BUT-75/VAR 5.22/VAR FEASIBILITY STUDY PID 117275

Original: May 1, 2024

| REVIEW COMPLETE | |

Figure 7: BUT-4 Flap Gate Plan View

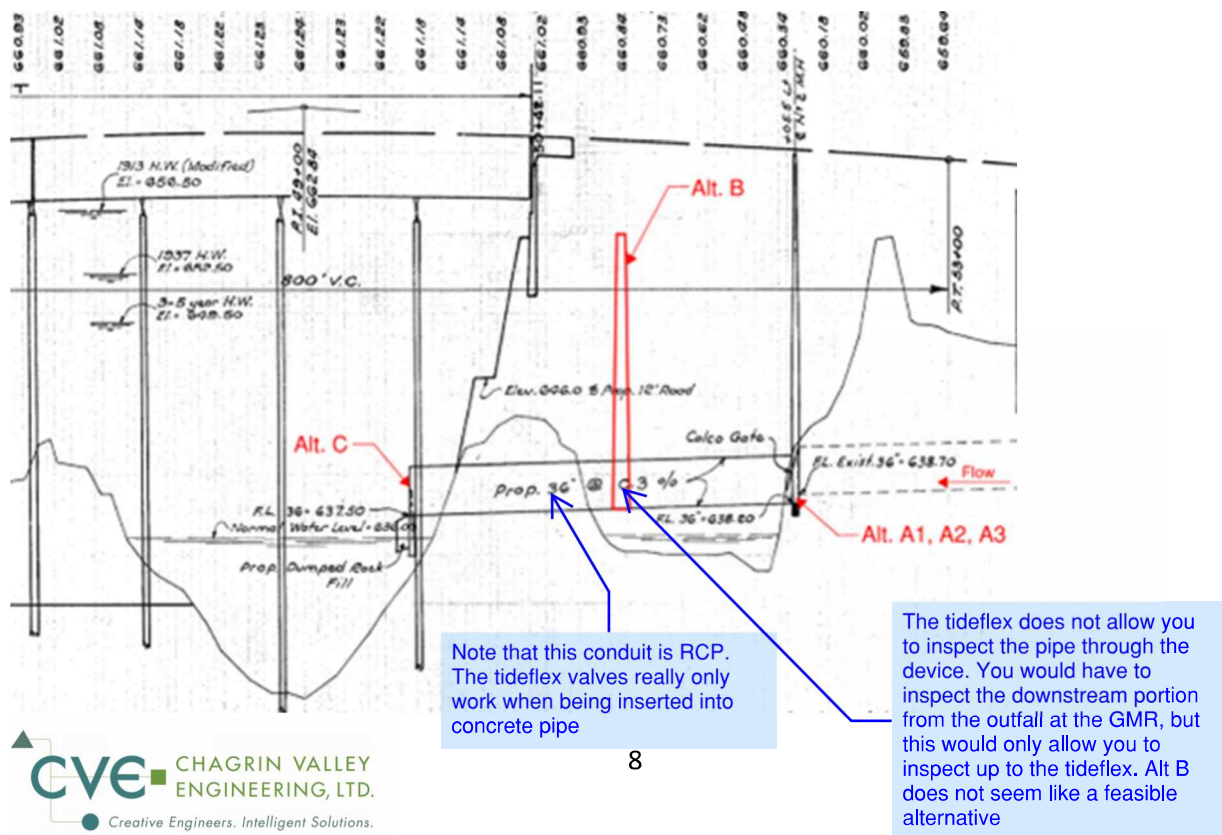
Note that this conduit is RCP. The tideflex valves really only work when being inserted into concrete pipe

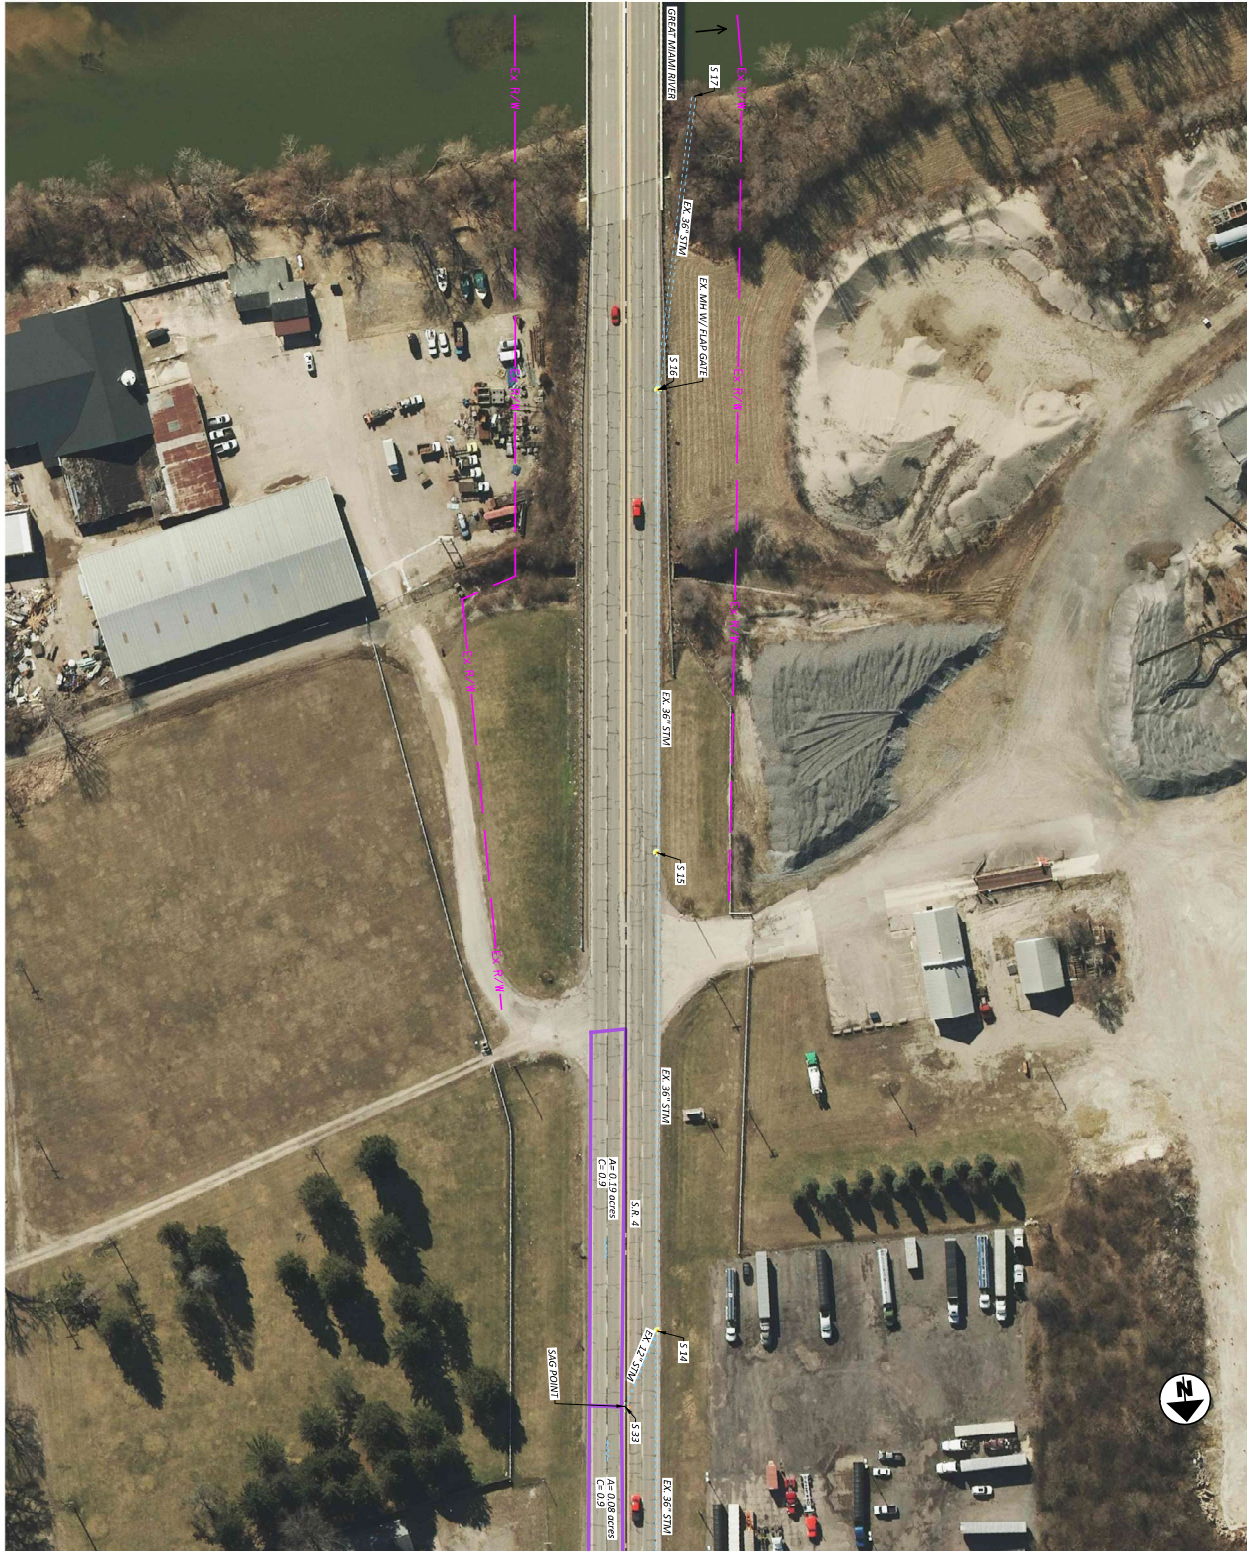
Will be difficult to achieve on the north west end of the project limits.

DRAINAGE AREA MAP
 BUT-4 - SHEET 2

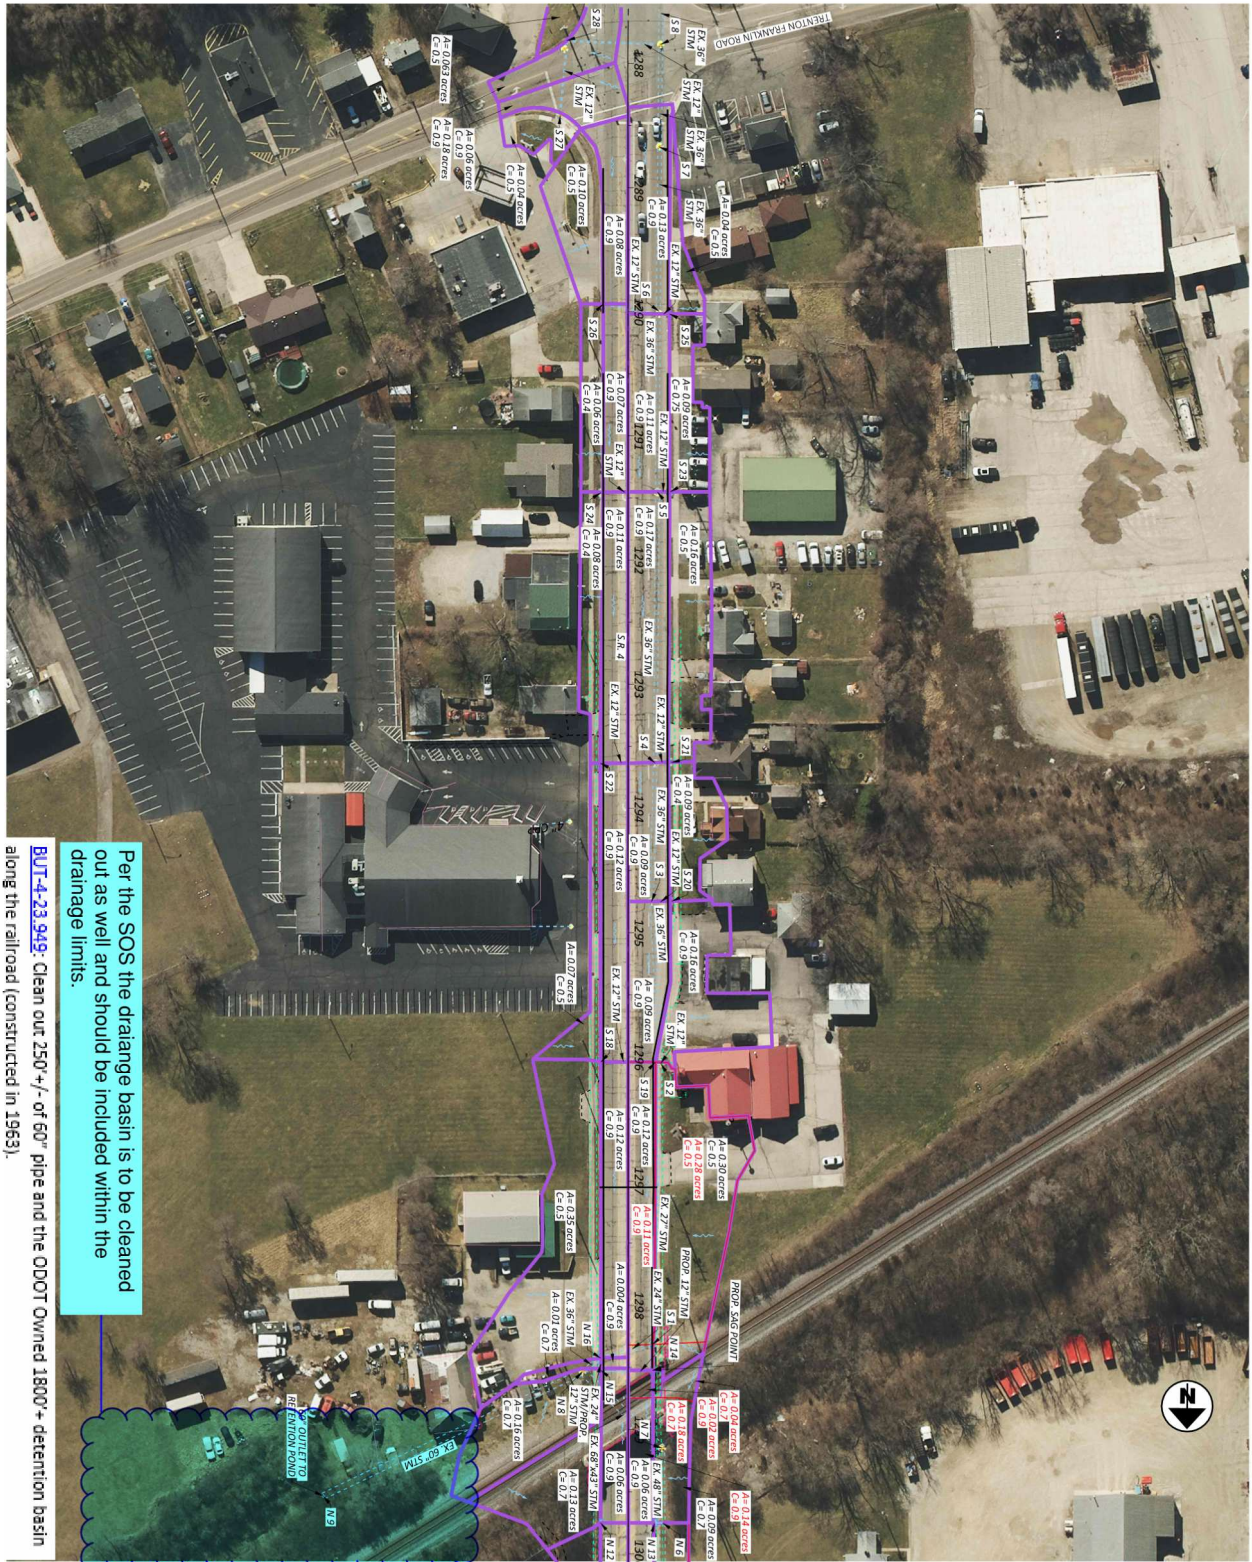
Per the SOS the drainage basin is to be cleaned out as well and should be included within the drainage limits.

**AND PROFILE - 15.0' VERTICAL CLEARANCE
 S.R. 4 - BEGIN TO STA 1299+50.00**

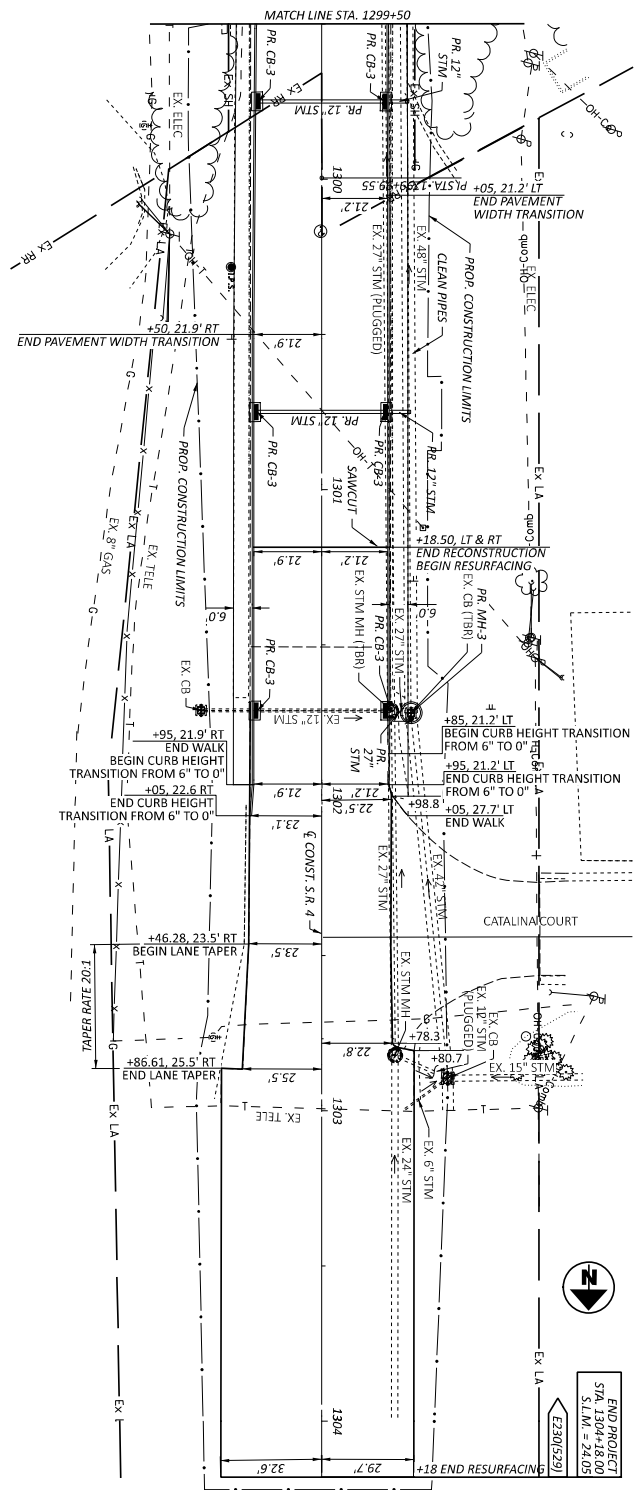
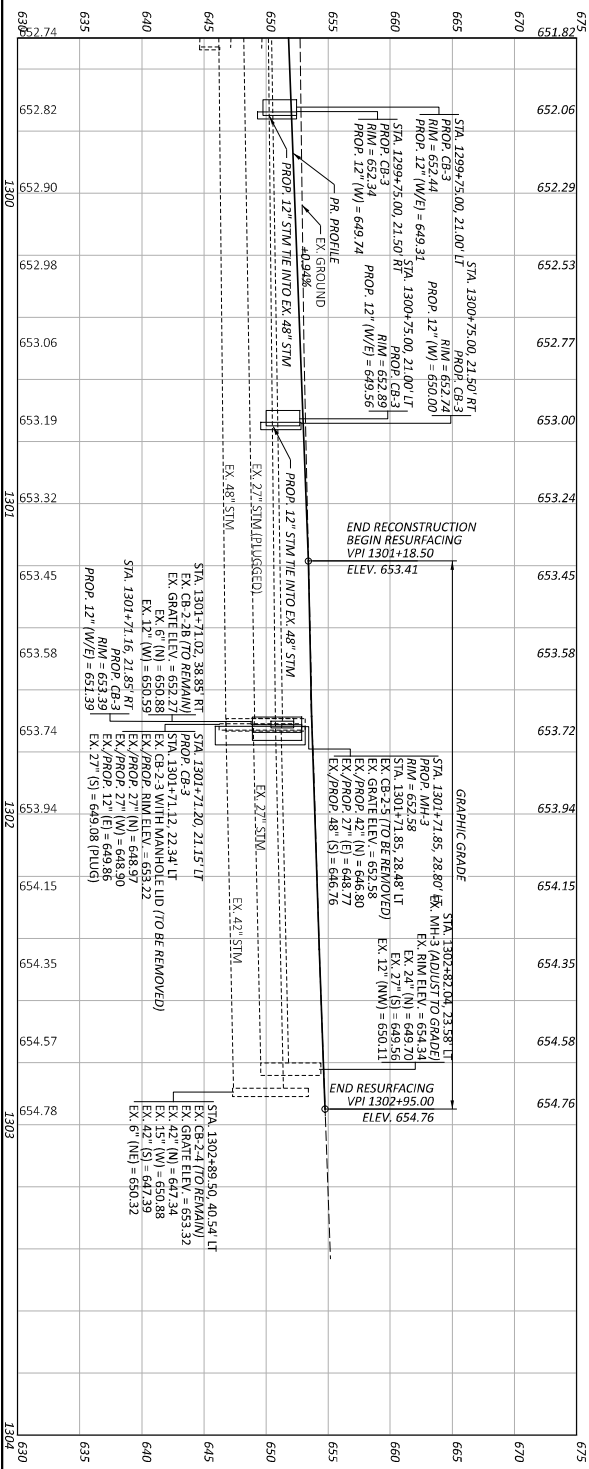
Comment from Brandon Collett and Tami Blinn with regard to the lowest vertical clearance we can get, the critical point on the shallowest pipe would be in the west gutter line. This has an invert elevation of 645.64 per their survey note their sheet says SE, but I think they mean NW. To determine the minimum PGL (conservatively at STA 1299+00) would be:

Pipe Height = 43'7.12
 Minimum cover over Pipe = 15'7.12
 Cross slope = 0.16% x 19.7 = 0.32
 Total = 63.32' = 5.28

The lowest corresponding PGL with regard to this elevation is 646.11 + 5.28 = 651.39. Per page 69 of 178 on their Feasibility Study they have an elevation 651.40 at this location with a 5' vertical clearance, therefore it seems attainable to get a 5' vertical clearance is attainable with sufficient cover over the elliptical pipe. With regard to the subgrade treatment below the top of the pipe, I talked with Joe Smithson, the engineer in charge of excavating and replacing 14' of subgrade around the pipe and under the bridge, we can instead of removing the subgrade under the entire bridge, the first layer shall be placed at the bottom of the 6' aggregate base and the second layer shall be placed at the midheight of the base. Where the curb height exceeds the standard curb height to avoid the bridge footing, the curb should be poured integral with the sidewalk with a 45 degree chamfer on the underside to give it a raker transition and it will improve durability.
